4.2 PRE-APPLICATION AND CONSULTATION FEEDBACK SUMMARY (CONTINUED)

4.2.4 PRE-APPLICATION MEETING 3

4.2.5 PRE-APPLICATION MEETING 4

FIGURE 94. Facade lighting strategy

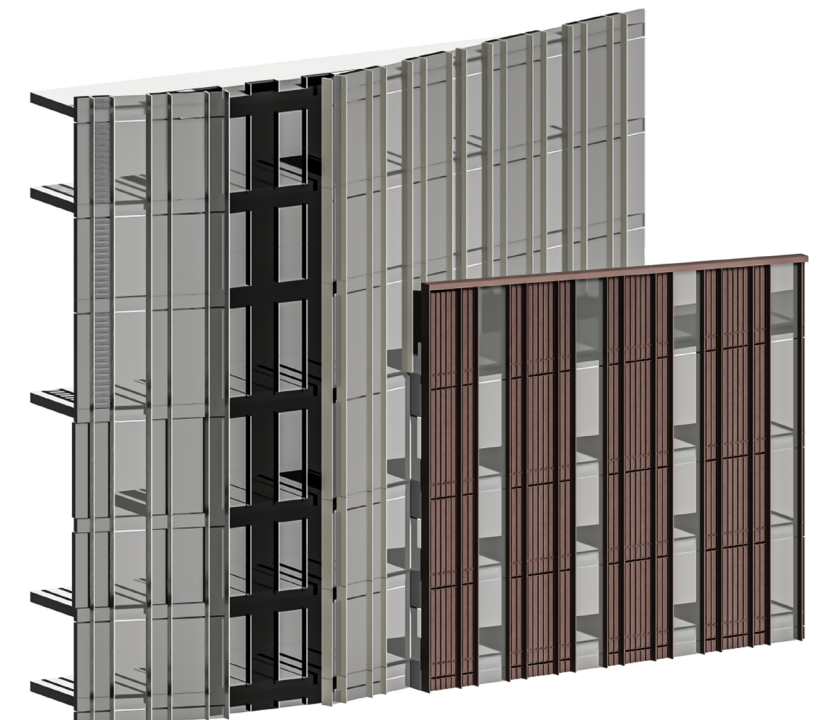
- Updates to design of top of building 'Spire' broadly supported as a design concept by Design Officer.
- Officers appreciated evolution of design development of building, accepting the tactile and textured treatment at low level as desired by QRP.
- Officers supported external lighting strategy, as an appropriate response to QRP comments.
- Officers supported activation of podium and seating area, and seen as a benefit over the approved scheme.
- Officers supported use of community art to elements of the facade, in appropriate response to QRP comments; encouraged input from Council / local groups to establish undertaking.
- Officers expressed a requirement for separate Sustainability Pre-App Meeting.

FIGURE 96. Visual of base of building

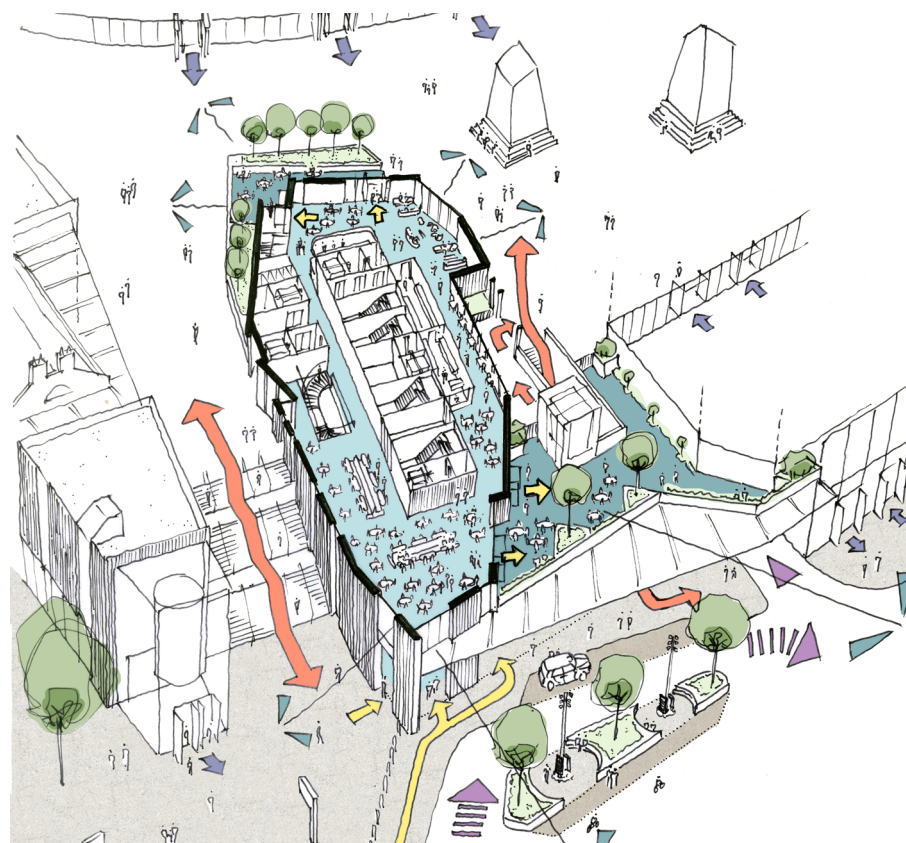
- Officers suggested further consideration on the vehicle drop off point to be formed like a 'plaza,' whilst exploring relocation of the loading bays to the street, with reference being made to the approved scheme. Recommendation would be to review original application and subsequent NMAs for clarification.
- Further consideration into how to retain elements of original approved scheme, with specific regards to the seating area in the 'plaza.'
- Officers queried scope for street level cycle parking.

FIGURE 98. Wind Tunnel Testing - completed development

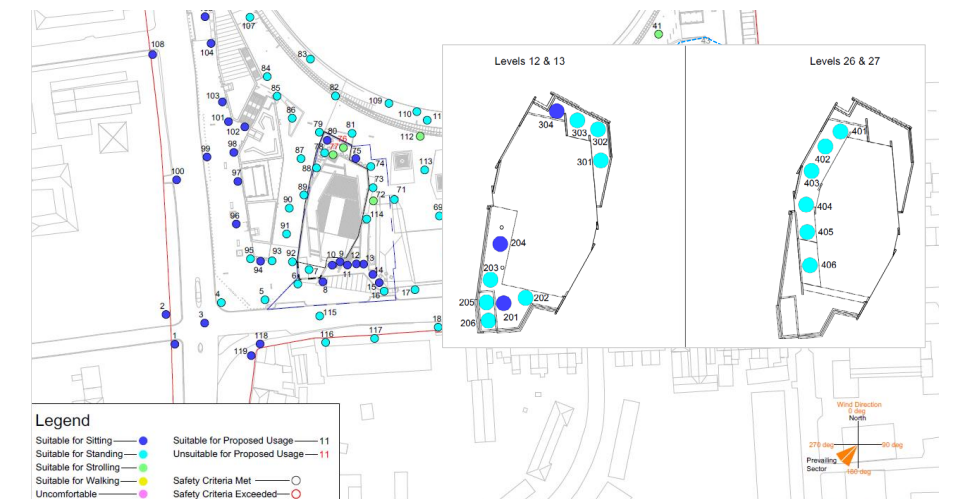
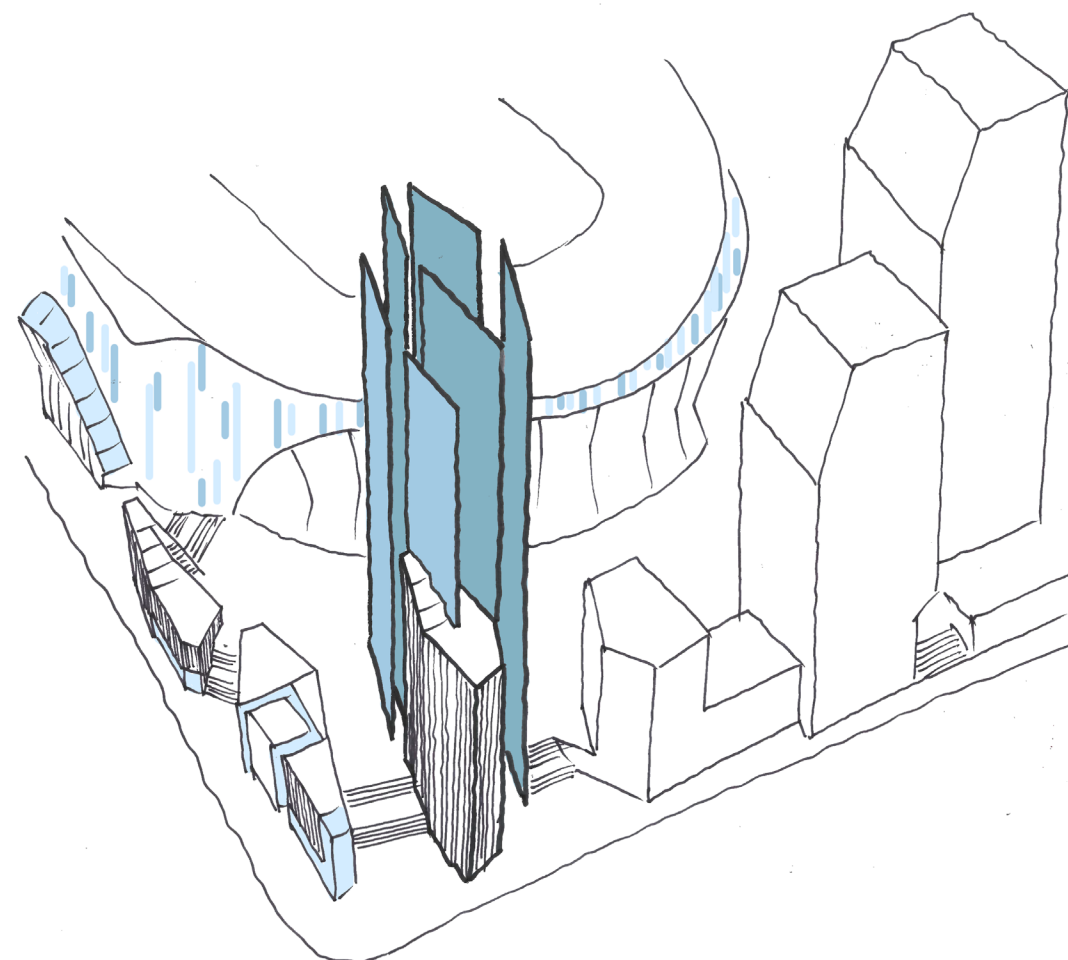
- Officers supported the principle of the blades extending at the top of the building to obscure views of the roof plant and were keen to see the detail.
- Officers welcome continued development on the design, balancing the elegance of the building and meeting sustainability standards.
- Further consideration into the revised approach to hotel entrances, with an emphasis on stairs access to the hotel restaurant on upper floors
- Officers to prepare preliminary comments shortly after the meeting and then follow up with detailed feedback.
